Regulatory Division
North Permits Section
SAJ-2006-4627 (MOD-AWP)
MODIFICATION 1

This letter is in reference to your request for a modification of Department of the Army permit SAJ-2006-4627 (IP-AWP) issued to FDOT, District 3 for the widening of 1.05-miles of State Road (SR) 79 in the Town of Vernon, Washington County.

By copy of this letter the U.S. Army Corps of Engineers is granting your request for a modification to the existing design which will include an additional 0.23 acre of impacts to waters of the United States. Specifically, the modification will allow the addition of 0.19 acre of impacts to wetland 4A, associated with an existing residential man-made pond, and 0.04 acres of rip-rap to be placed at the northeast bridge abutment

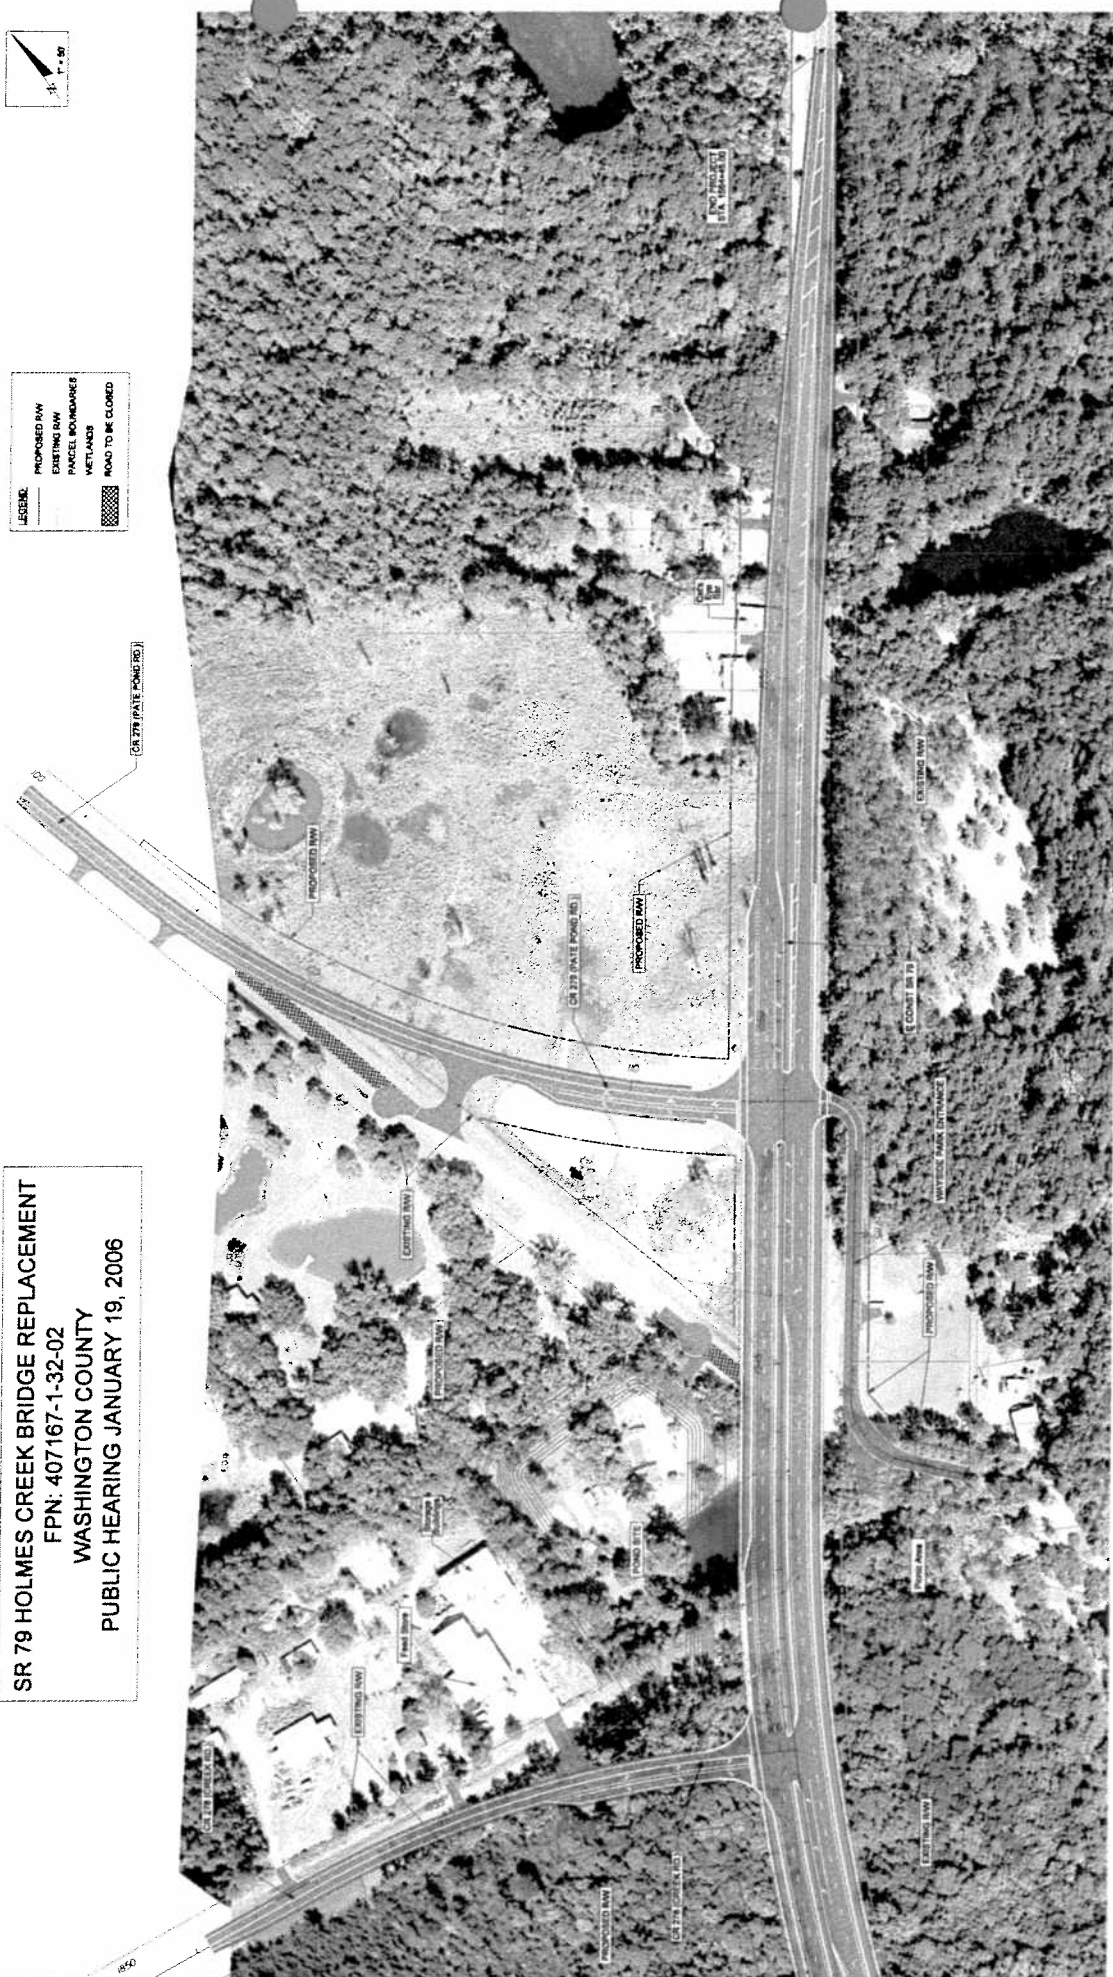
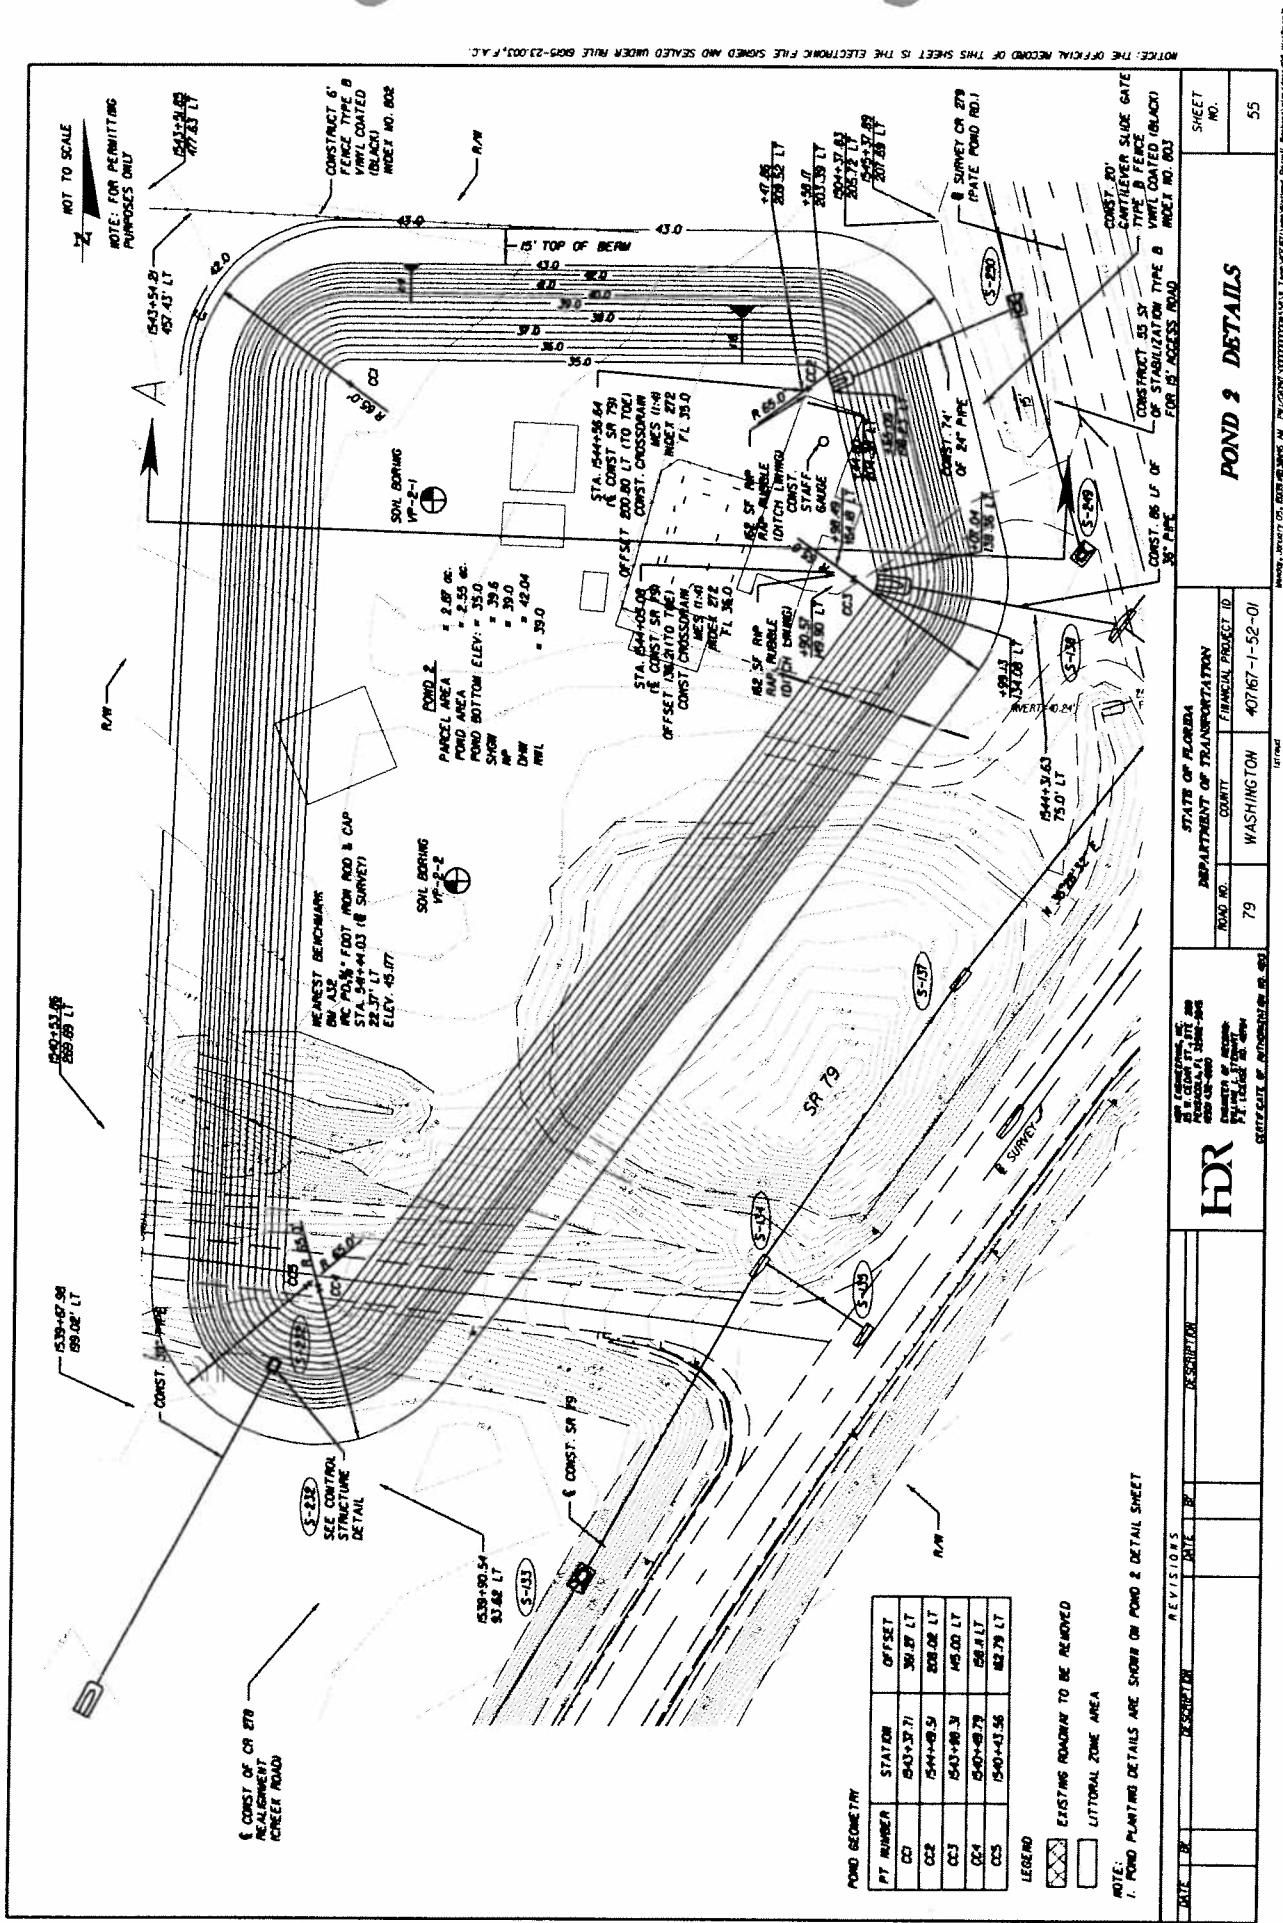
- 1. Applicant:** Florida Department of Transportation, District 3
Attn: Joy Giddens
P.O. Box 607
Chipley, Florida 32428
- 2. Reason for supplement:** Plan updates and design changes call for 0.19 acres of additional impacts to wetland 4A, associated with an existing residential man-made pond, and 0.04 acres of rip-rap to be placed at the northeast bridge abutment. Modifications, total 0.23 acres of additional impacts to waters of the United States.
